# PLANNING ASSESSMENT REPORT

## Stage 11 Claymore

**Subdivision comprising 92 torrens title residential allotments, 1 residue lot and associated site, civil and landscape works including the removal of 190 trees.**

**Figure 2 - Clause 34A Certification May for Claymore Masterplan Overlay (boundary comparison)**  
 (Source of plan supplied direct by Landcom NSW)

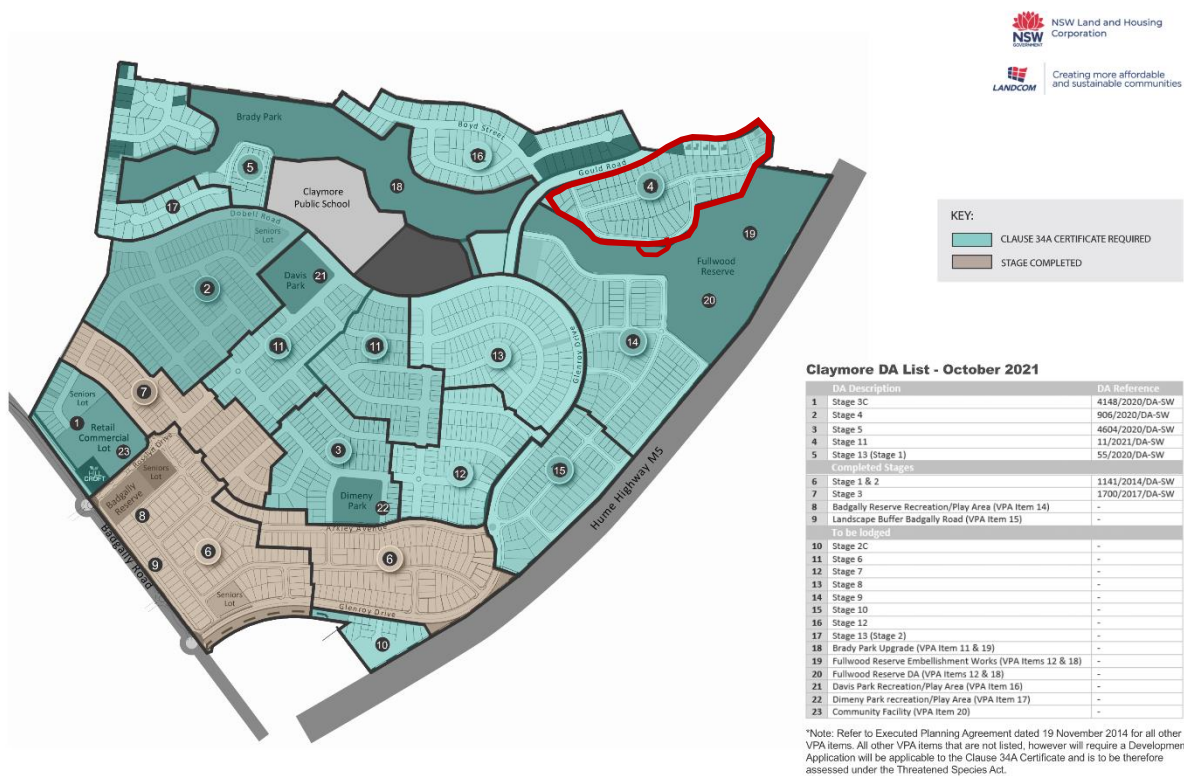
The subdivision DA is within the Clause 34A Certification area but impacts within the boundary of the site with respect to Fullwood Reserve due to a proposed stormwater basin and associated works. I refer to the approximate overlay below (Figure 2 & 3).

Based on the overlay the proposed sediment basin is affecting 3 additional native trees as shown in the Arborist Impacts Statement (Arborsaw 2022). These trees are within the area mapped as Fullwood Reserve (Figure 4).

Based on my understanding of the Clause 34A certification it is my view that the sediment basin is not covered under the Clause 34A Certification as the certification applies to the subdivision lands only as shown mapped in Figure 2. The proposed basin is within an area nominated for future open space embellishment works subject to DA approval.

**Figure 5 – Extract of Claymore Urban Renewal Concept Plan**  
(Source Cumberland Ecology 2020)

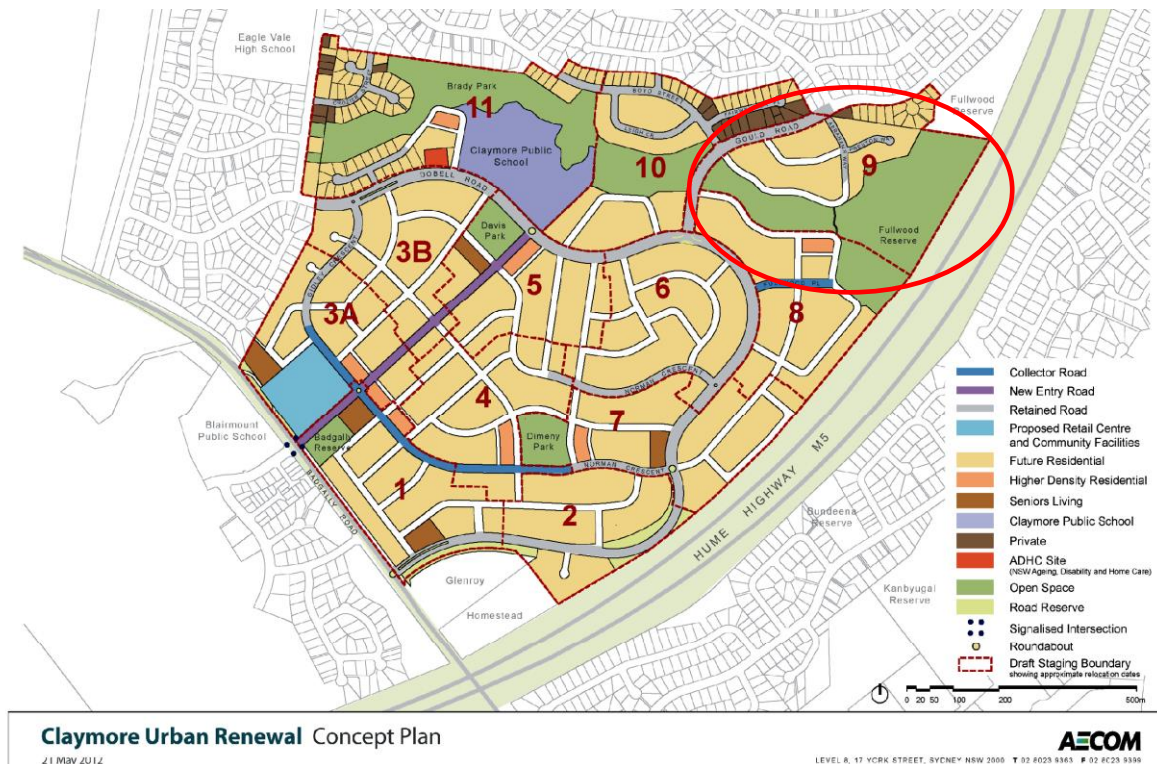
I have reviewed the DA staging plan in accordance with the approval Claymore Masterplan. This indicates that the subdivision is within Stage 9 of the Concept Masterplan which includes Fullwood Reserve. It is my understanding the approved VMP is not being staged but is being implemented over a general timeframe with reporting requirements.

The proposed bushland revegetation works, and the approved Vegetation Management Plan (Cumberland Ecology 2015) was prepared to satisfy the biodiversity offset requirements for the project.

**Figure 7 – Overview of the general arrangement plan**  
(Source SMEC – 17 November 2021)

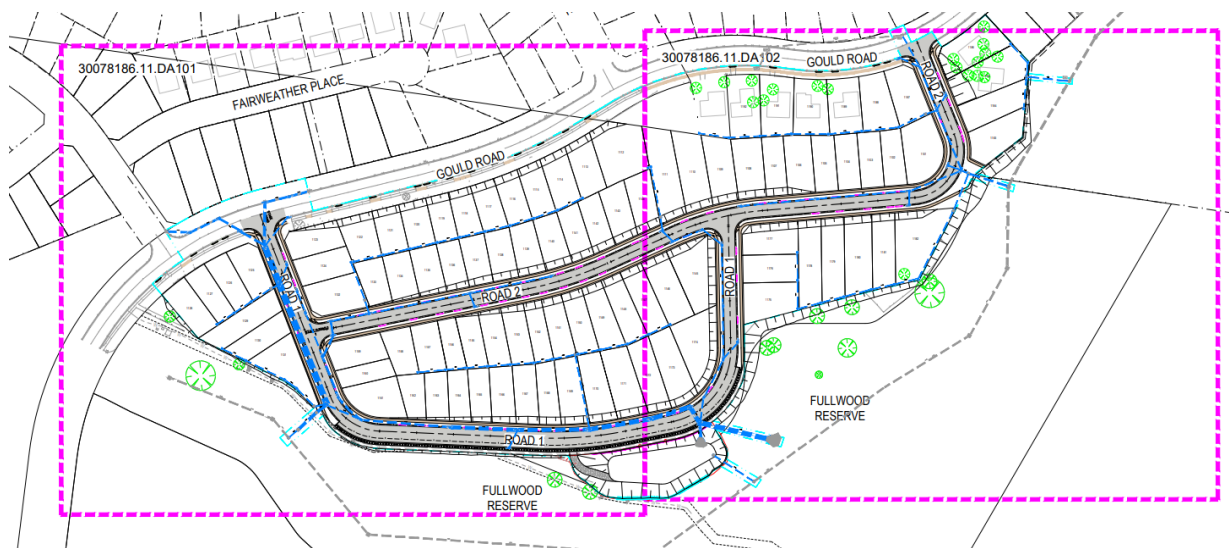
I have reviewed the proposed civil works inclusive the drainage plans and proposed bioretention basins (Figure 7).

**Figure 9 – Cut and fill plans resulting in complete removal of all trees within Stage 11 DA Subdivision**  
(Source SMEC 17 November 2021)

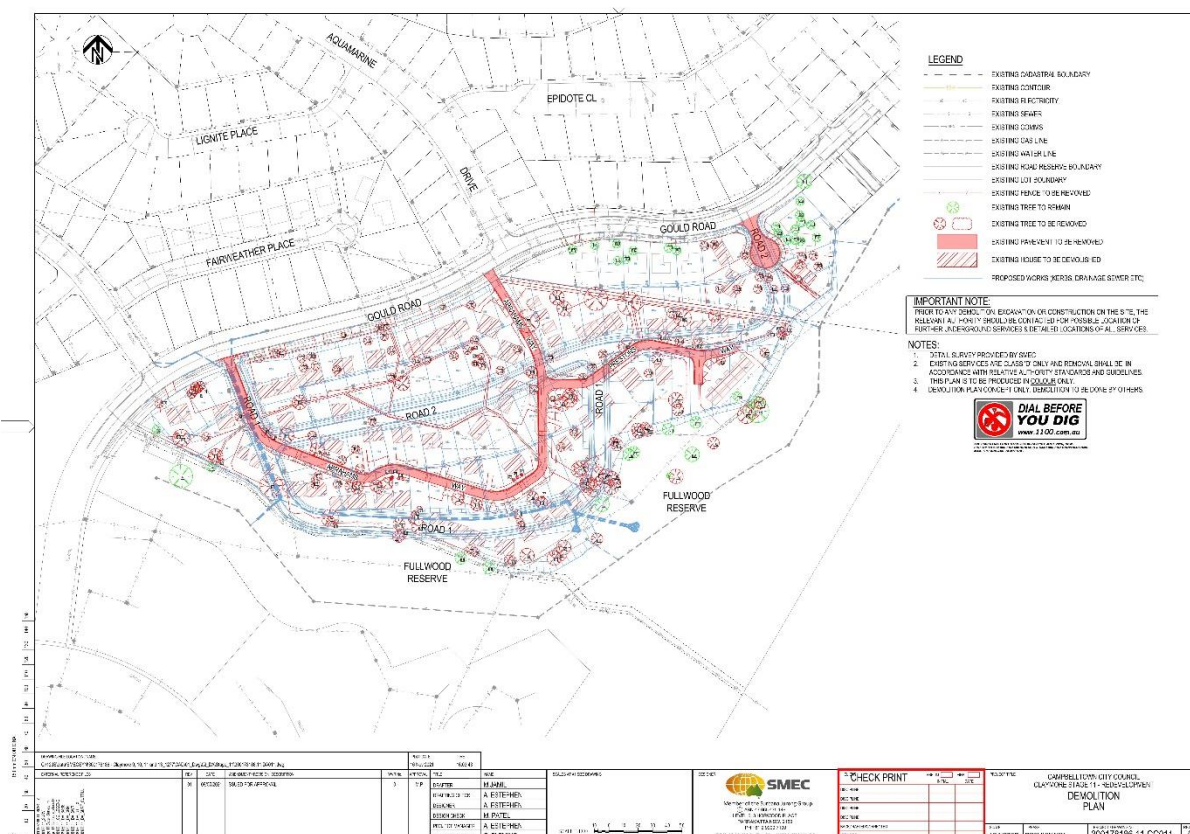
Arborsaw 2022 reports that **190 Trees** require removal to facilitate the project. Following layout adjustments, it has been determined that 46 trees can be retained if the tree protection measures in the report are adhered to. Tree Removal and Retention details are provided on a per tree basis within the tree data table. Previous errors in the 2021 report have been corrected.
